Re: Mathews County/384 Old Ferry Road
TSG No. VA22105.FOR

With your authorization, we performed a limited forensic structural review of the one (1) story, approximately 1,260 square foot, commercial building located at 384 Old Ferry Road within Mathews County, Virginia. The purpose of our review was to determine if the as-built construction of the raised foundation met the construction documents and specifications submitted to Mathews County.

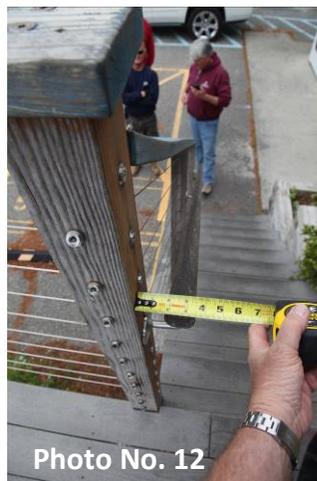
Additionally, we noted that a 4'-0" cantilevered extension had been constructed along the right elevation rather than the 2'-8" extension shown on the construction documents provided by Bay Design. Closer review revealed the 4'-0" extension along the restaurant was supported by 4" x 4" posts bearing directly onto the existing slab on grade without anchorage, see Photo No. 8
